# VALUE ENGINEERING STUDY

## WIDEN AND INSTALL HOV LANES ON I-20 WEST WESTCORRIDOR DOUGLAS, COBB & FULTON COUNTIES, GA

Georgia Department of Transportation  
#2 Capitol Square, SW  
Atlanta, Georgia 30334-1002

27 October 2005

**PROPOSAL NUMBER:** CM-2.0

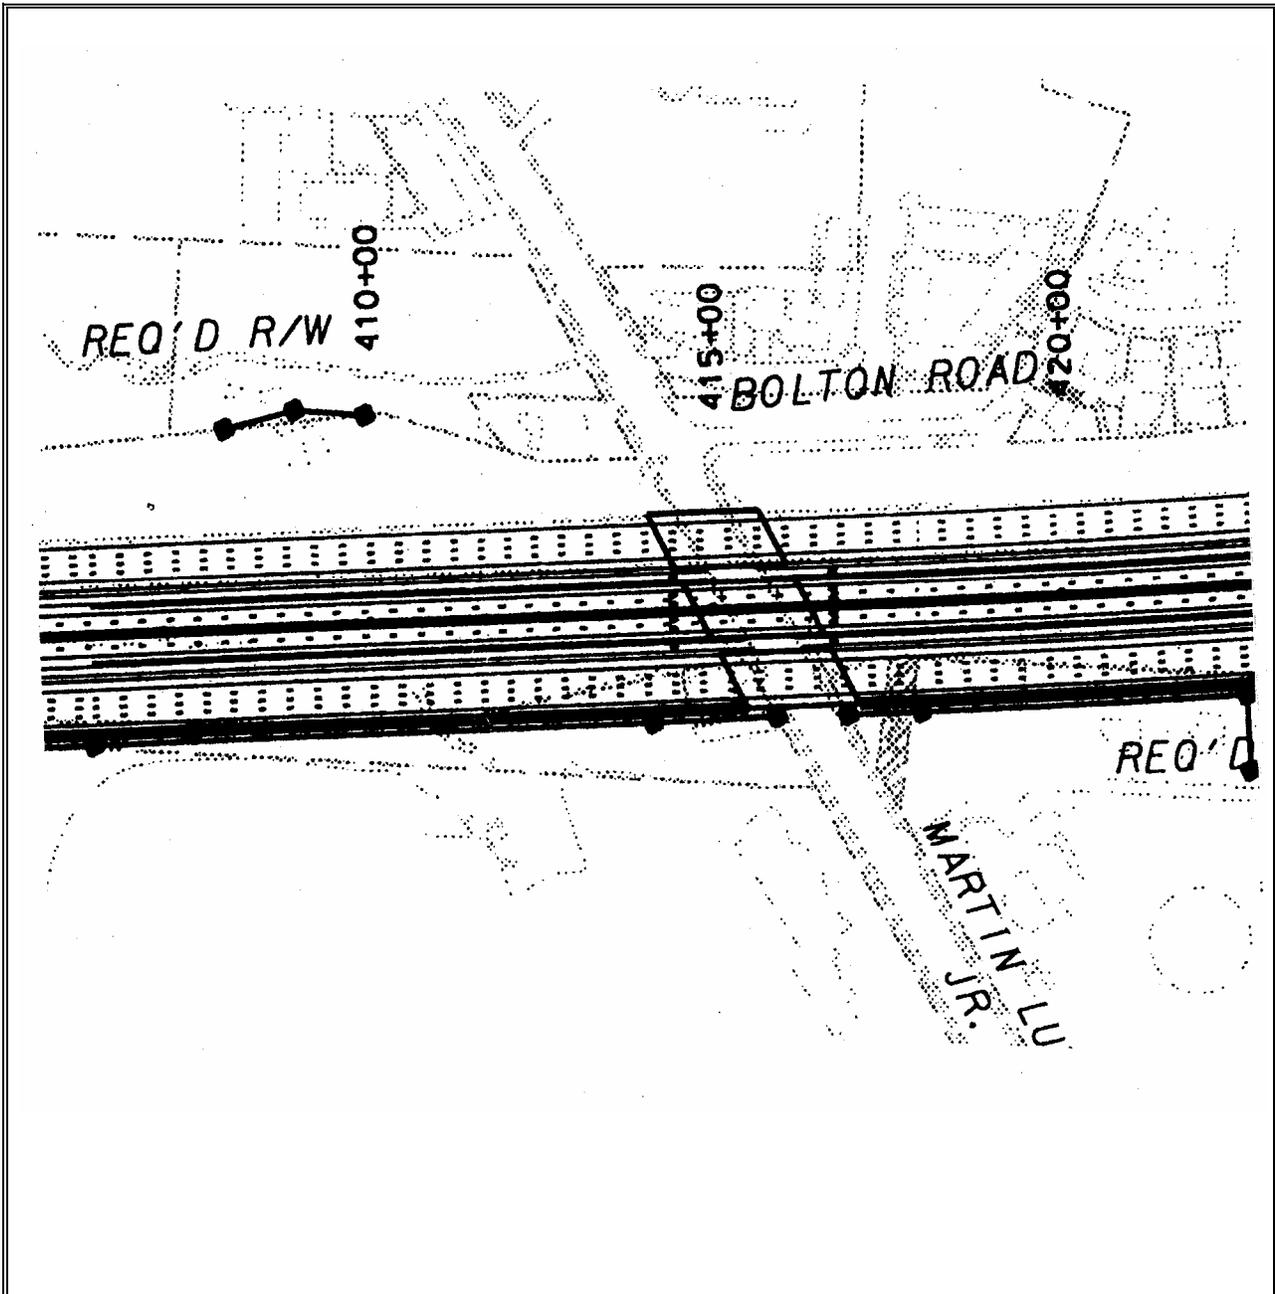
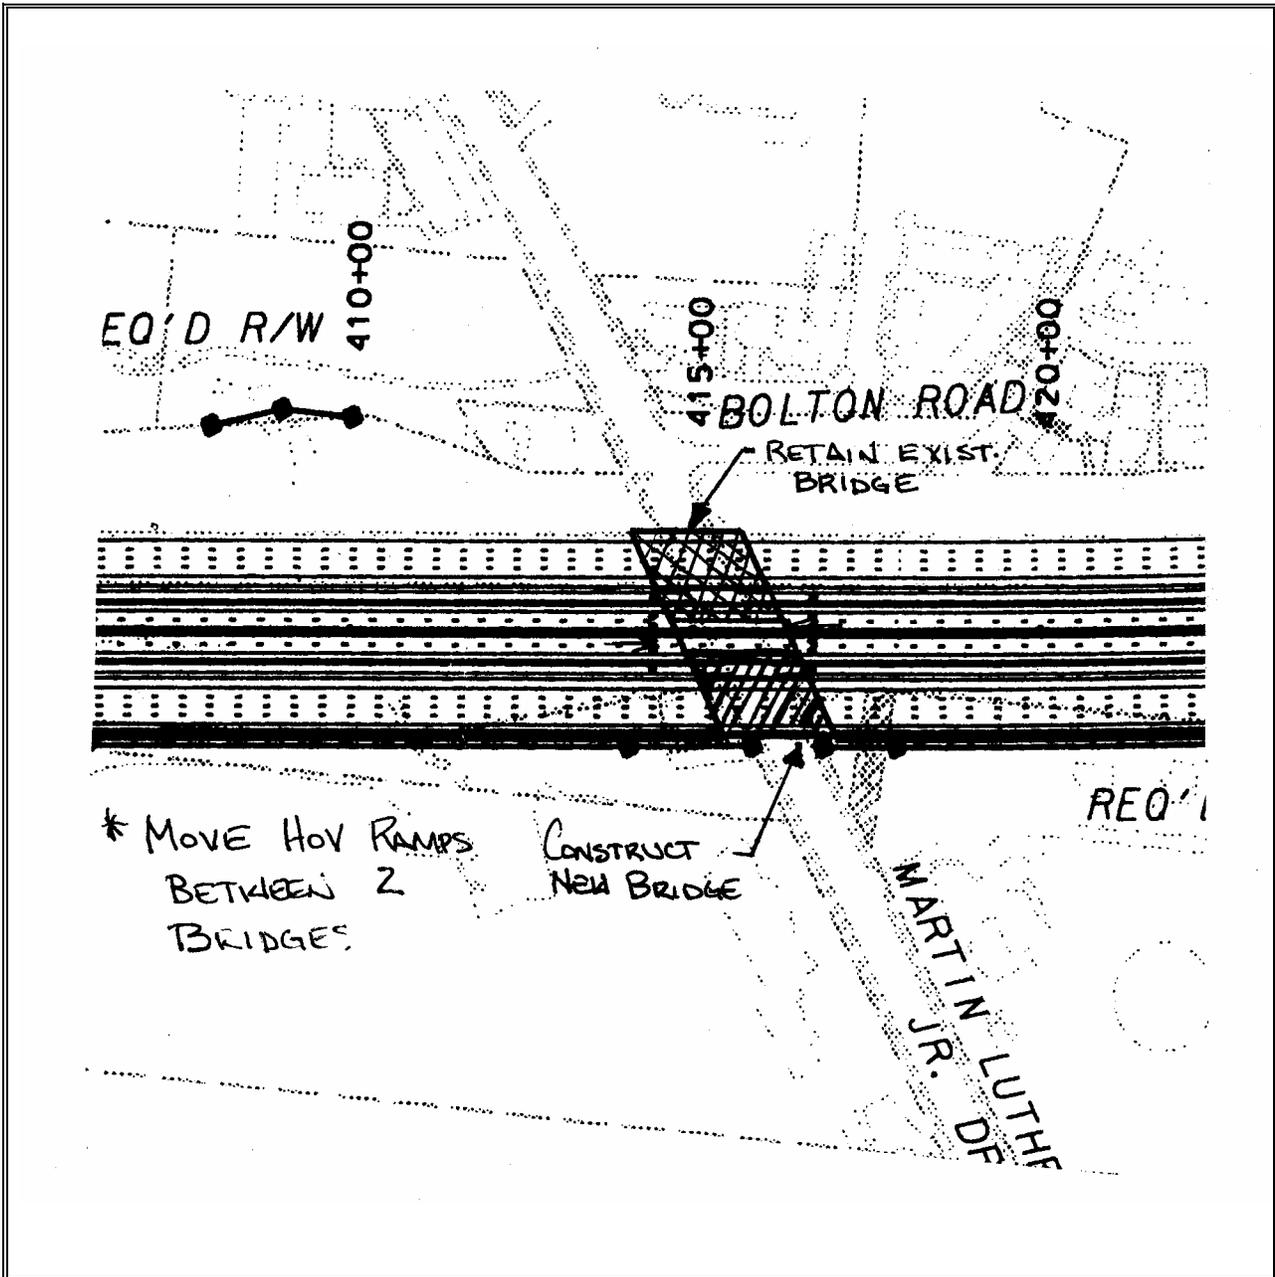
**PROPOSED CHANGE:** Retain the existing bridge over MLK Drive, redesign the HOV ramps to exit from the left side to MLK Drive and construct one new bridge.
